## **Preliminary Septic Capacity and Well Water Quality for Properties Surrounding Map 7, Parcel 49**

Submitted respectfully by Meredith C Wesolowski, 34 Greenwood St., Sherborn, MA 01770

Figure 1: Google-Maps generated locations of properties used to determine average septic capacity per acre, which was calculated to be 208.5 gpd/acre.

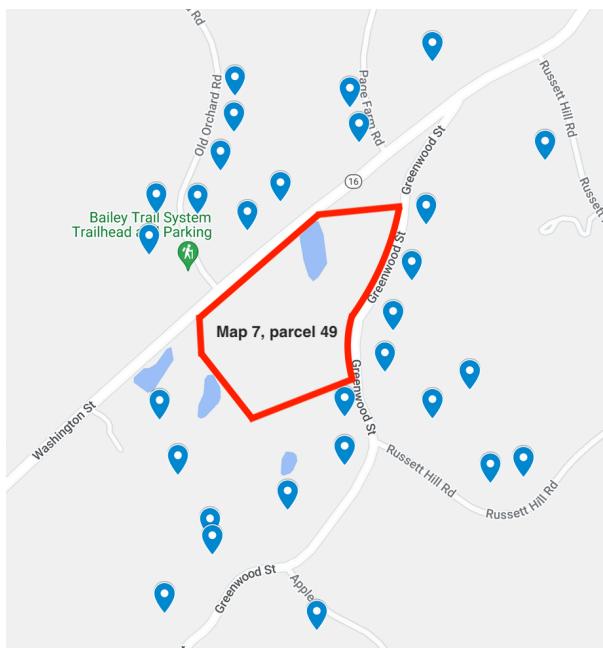
Septic system capacities (in gallons per day or gpd) and lot sizes (in acres) were collected for 34 properties surrounding Map 7, parcel 49 (Fig. 1). The average septic capacity for these properties was calculated to be 208.5 gpd/acre. **If Map 7 parcel 49 were developed to carry the same septic density as the surrounding properties, the entire parcel would have a total septic capacity of 3857 gpd** (208.5 gpd/acre \* 18.5 acre = 3857 gpd), **or 35 total bedrooms between both proposed developments.** This value is consistent with a seven-house development proposal submitted in 2019 by a different developer (and whose schematic plan is currently posted as the “by-right” document<sup>5</sup> for the Greenwood Homes proposal).

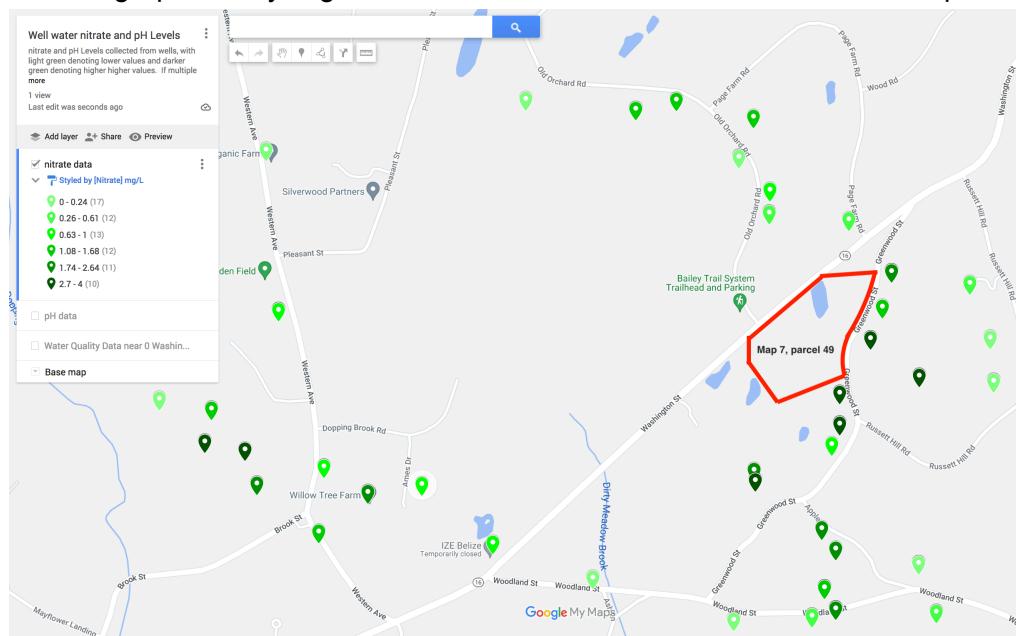
To address questions related to groundwater quality in the area, as many water test reports as could be located during ~8 visits to the BOH office for the area surrounding Map 7, parcel 49 and its abutting wetlands were collected from the BOH and local homeowners (this collection process is still on-going, and additional data for an increased area will be added to future reports). A map of properties with water quality reports collected to date is below (Fig. 3), as well as several graphs analyzing well water nitrate concentrations from these reports.

**Figure 4: Historic, reported well water nitrate concentrations (mg/L) are plotted against test year for those properties mapped in Fig. 3. Data from selected properties on Greenwood St. are plotted in blue and described below, while data from all other properties are plotted in green.**

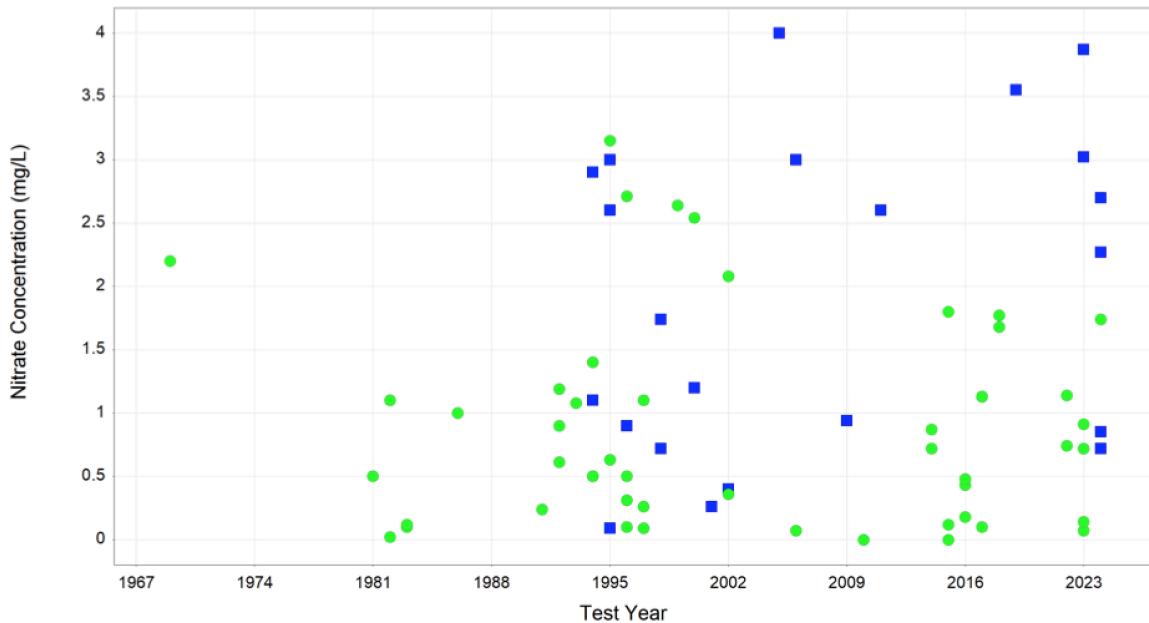
Based on 73 water quality reports tested over 55 years, **the average reported well water nitrate level for all properties was 1.2 mg/L**, with a range from “not detected” to 4.0 mg/L and a standard deviation of 1.1 mg/L.

Although data collection and analysis are not yet complete, one unexpected observation was made: **existing homes on Greenwood St. most proximate to Map 7, parcel 49 (19-64 Greenwood St.) reflect a higher average reported well water nitrate level (1.9 mg/L<sup>7</sup>) when compared to the surrounding vicinity.** This represents a nearly 60%-greater nitrate concentration when compared with the average area results. Nitrate concentrations detected at or above 3 mg/L for these addresses (see Figure 5 for map) date back as far as 1995, which is the first test date on record for these homes, and was the first year homes with addresses between 19-34 were built (the last being completed in 2005).

Figure 5: Select addresses on Greenwood St. with a detected average nitrate level of 1.9 mg/L.

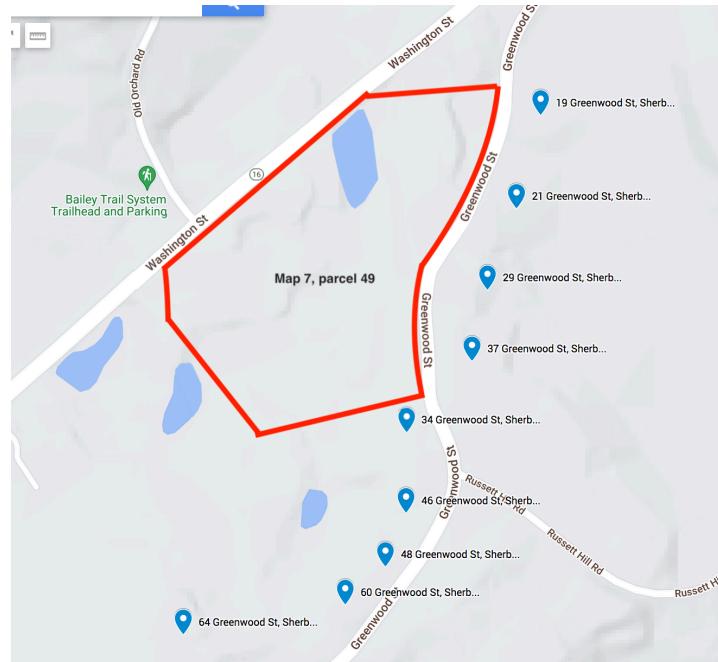
The reasons for this ~60% difference in groundwater nitrate levels are not yet understood but will be looked into further. At present, possible influences include groundwater pH (which is notably lower than average for these homes, with pH being important factor in the removal of nitrogen from septic effluent<sup>8</sup>) and site-specific soil characteristics (these homes are unique for the area in that they sit on a swath of 103C, Charlton-Hollis-Rock outcrop, as does much of Map 7, parcel 49, see Fig. 6). More investigation is required to better understand and characterize this observation.
